**STAFF REPORT**  
**COMMUNITY DEVELOPMENT DEPARTMENT**

HEARING DATE: June 7, 2022  
 TO: Mayor & City Council  
 FROM: Joseph Dodson, Associate Planner  
 208-884-5533  
 SUBJECT: H-2022-0004  
 Alamar Subdivision  
 LOCATION: The site is located at 4380 W. Franklin Road (Parcel #S1210346603), near the northeast corner of N. Black Cat Road and W. Franklin Road, on the north side of Franklin Road, in the SE 1/4 of the SW 1/4 of Section 10, Township 3N, Range 1W.

Annexation and Zoning of approximately 8.23 acres of land with a request for the TN-R (Traditional Neighborhood Residential) zoning district and a Preliminary Plat consisting of 51 building lots (30 single family attached lots and 21 detached single-family lots), 6 common lots, and 2 other lots (common driveways) on 5.63 acres in the proposed TN-R zoning district.

D. Phasing Plan (dated: ~~March 15~~ May 30, 2022)

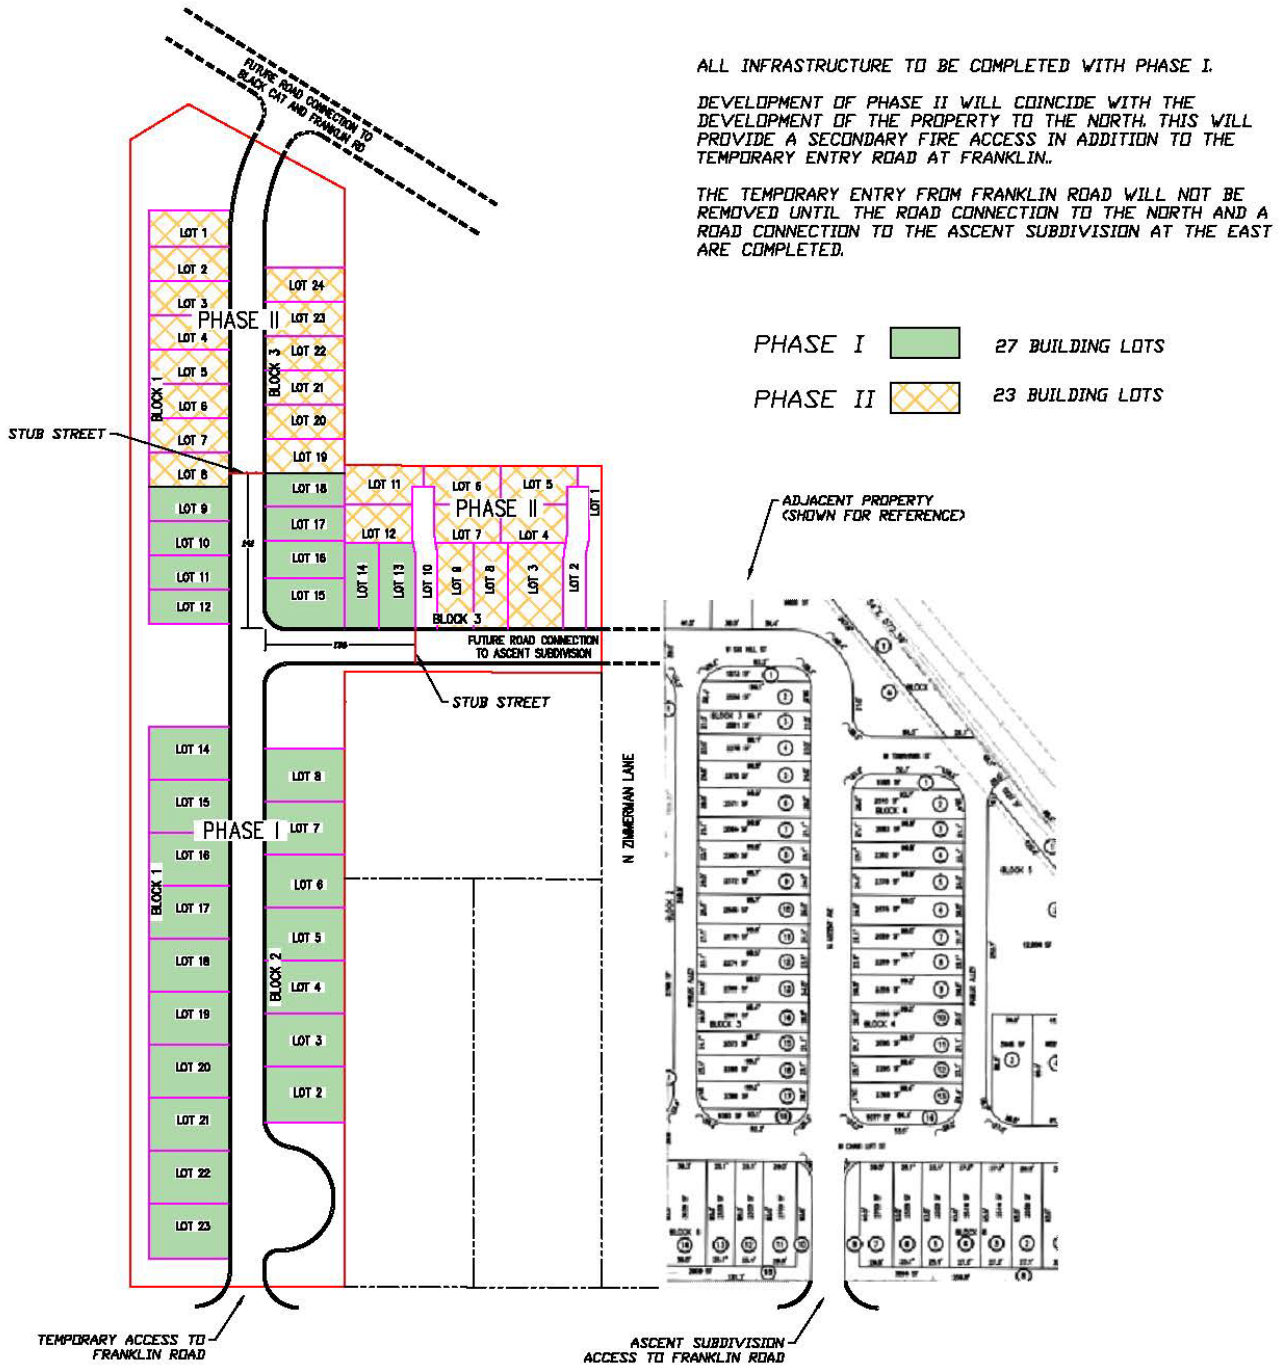
with an average lot size of 2,762 square feet. According to the submitted plans, the plat is currently proposed to develop in two phases due to the available access to the site being only from Franklin Road at this time. The phasing plan depicts construction of 22 building lots in the southern half of the site with three open space lots (including the largest centralized open space lot) in Phase 1 with the public roads terminating less than 150 feet from the internal intersection—thus, 20 of the 21 detached single-family lots and two single-family attached lots are proposed in Phase 1. Phase 2 then depicts the remaining building lots to the north and east of the centralized intersection to be constructed along with some remaining open space lots along the north boundary.

Further, Phase 2 depicts the north-south local road within the site terminating at the north boundary over the Purdam Gulch stub drain with a slight curve to the northeast to match the property line. Staff has had multiple discussions with this Applicant and the Developer of the Zimmerman property to the north in regards to the proposed termination of the north-south local street within this development. The issue that has been brought up is the preferred alignment of this street at the north property line and consequently where it would connect to the extension of W. Aviator Street, the collector road required to be developed with the project to the north. Staff notes it has been the City's practice to require an Applicant change their road alignment based upon conceptual drawings of a project that has not yet submitted to the City. **However, Staff has included a DA provision to allow this Applicant the flexibility to revise the road alignment and lot layout with the future Phase 2 final plat should they be able to work out a mutually beneficial agreement with the adjacent property owner; this is predicated on IF the property to the north receives approvals from the City. This recommended provision does not require this Applicant revise their plat at any point but its intent is to provide flexibility to the Applicant to make any necessary revisions to the plat without having to go through the hearing process for subsequent changes that do not increase the number of building lots or drastically change the project design but help the overall road network in this area of the City.**

- a. Future development of this site shall be substantially consistent with the approved plat, landscape plan, phasing plan, and conceptual building elevations and floor plans included in Section VII and the provisions contained herein, except that phase 1 may be modified to include additional building lots on the 1-acre east leg of the project should a public road connection to W. Atomic Street occur.

- b. Final alignment at the north property line of the north-south local street proposed with the subject applications shall be determined at the time of the second final plat submittal to allow the Applicant flexibility to work with the adjacent developer to the north/northeast—the Applicant shall not be permitted to increase the number of buildable lots with any road alignment revisions.

## F. Open Space Exhibit

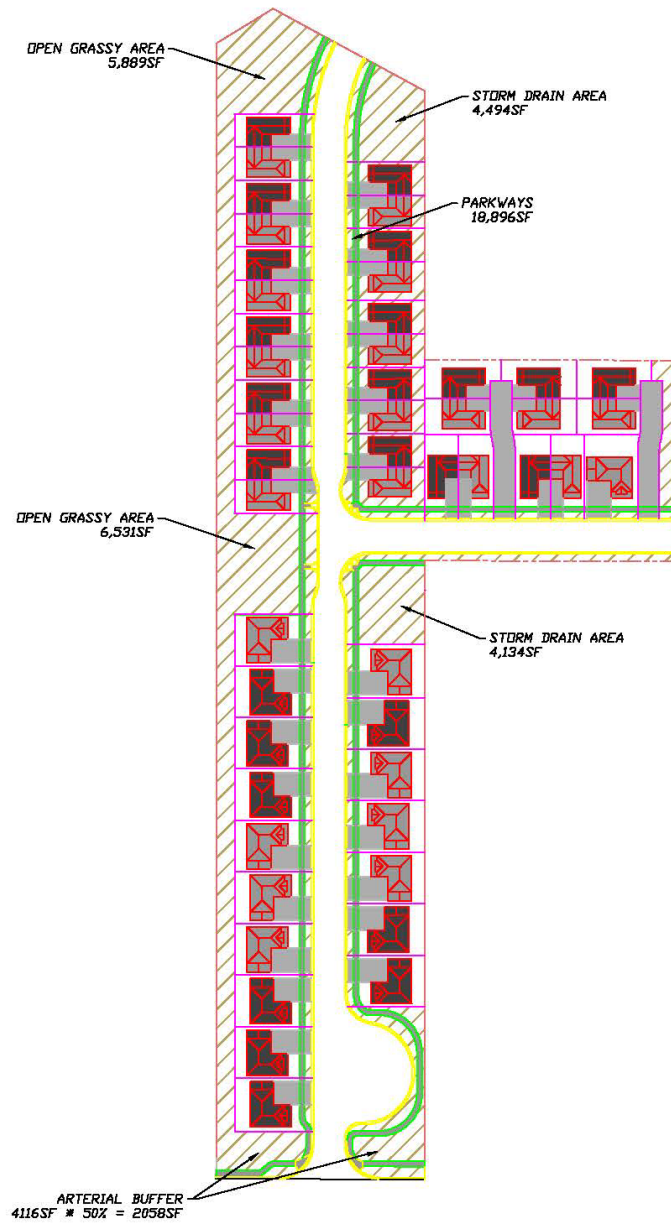
The area of the preliminary plat is 5.63 acres within the requested TN-R zoning district. According to the standards listed in UDC 11-3G-3, a minimum of 15% qualified open space should be provided for projects over 5 acres within the TN-R district. As noted above, the Applicant did not submit a separate open space exhibit so Staff had to dissect the submitted plans and the applicable areas that qualify.

*Based on the plat area of 5.63 acres, the minimum amount of qualified open space required to meet UDC 11-3G-3 standards is approximately 36,786 square feet. According to Staff's analysis of the submitted plans, the Applicant is proposing approximately 32,500 square feet of qualified open space; this area does not meet the minimum 15% requirement. This includes the proposed parkways, arterial street buffer to Franklin, the central open space lot (portion of Lot 12, Block 1), and other smaller areas of open space throughout the site. As discussed throughout this report, there is potential of the entire Lot 12, Block 1 counting towards the qualified open space if additional pedestrian facilities are added to this lot. Specifically, Staff recommends adding a 5-foot wide micro-path from the detached sidewalk along the local street in two locations; within the central open space lot and in the open space area in the northwest corner of the site. Further, additional pedestrian facilities would need to be added to this lot within the drain easement area to create a looped system for the project. These cumulative revisions are required in order for this easement area of Lot 12 to count towards the qualified open space. If these revisions cannot occur, the Applicant will need to add approximately 4,300 square feet of additional qualified open space in the project—because of the site design, this would likely require the loss of building lots.*

OPEN SPACE REQUIREMENT: 5.63 ACRE \* 15% = 36,788 SF

11-3-B.1.d	OPEN GRASSY AREAS		= 12,420
11-3-B.1.c	PROTECTIVE BUFFER ON DITCH		= 0
11-3-B.1.e	ARTERIAL BUFFER (50%):	4,116SF * 50%	= 2,058
11-3-B.4	PARKWAYS EXCLUDING DRIVEWAYS	18,896SF - 5148SF	= 13,748
11-3-B.5	STORM DRAIN (11-3-B.1)		= 8,628
	TOTAL:		<u>36,854</u>
